SUBJECT : The content of modification to meet the FCC Requirement.

Product : Color Display Monitor
Model/type : 720NF
FCC ID : MSA720NF

SUS 0.1t

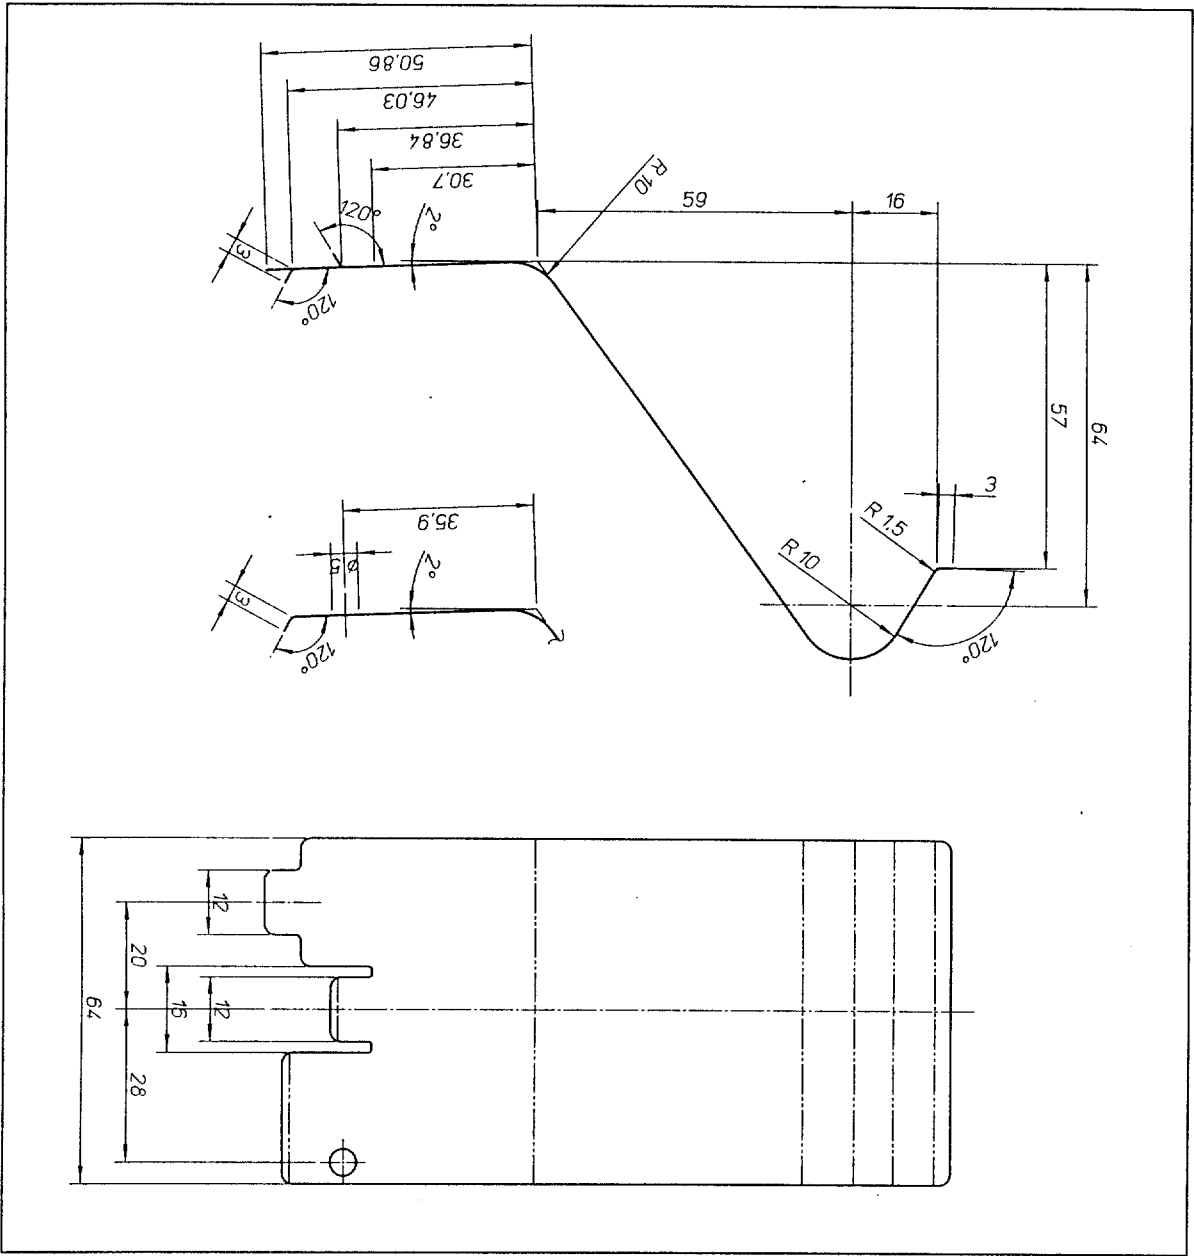
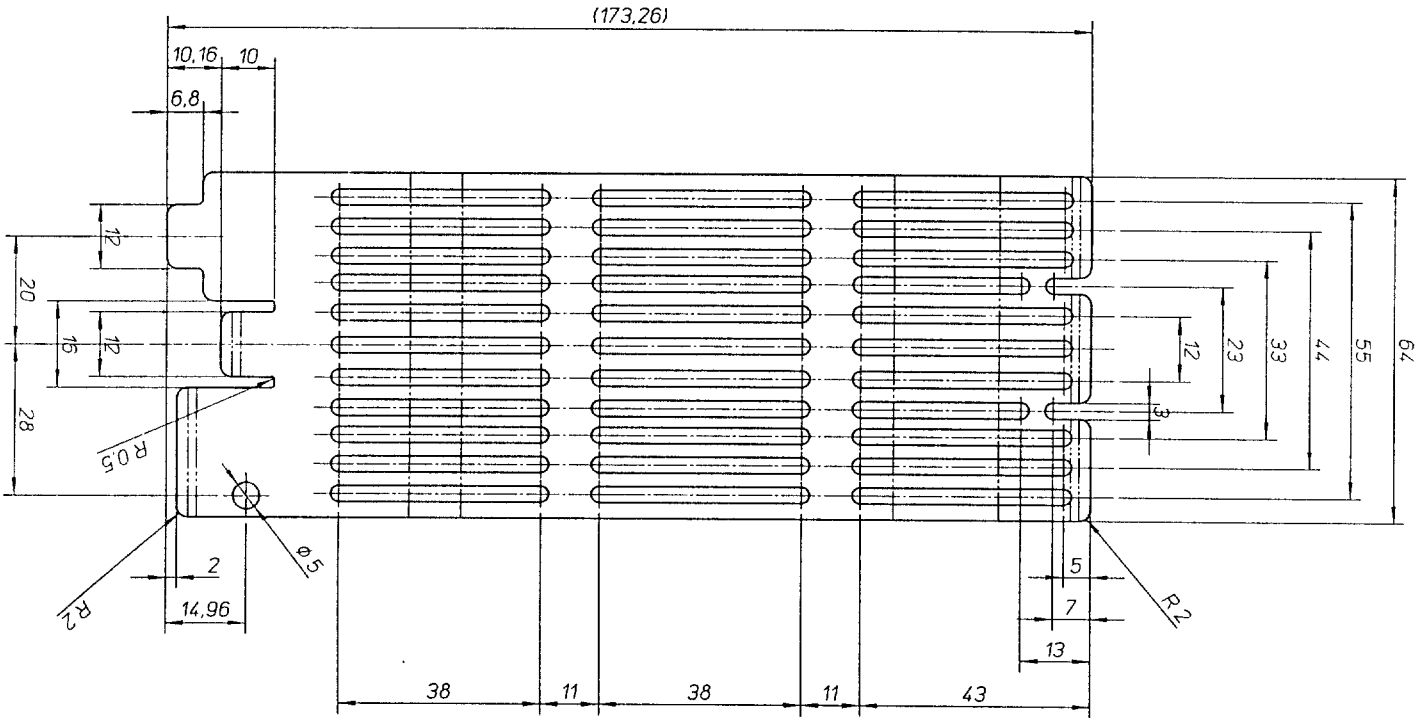
- This product will be attached following metallic material between main chassis and video chassis to meet requirement of radiated emission.
- This modification will be applied in this product and kept a record of EMI Test report.

- Material name : SUS
- thickness : 0.1mm
- Shape and size : Please, See attached annex A
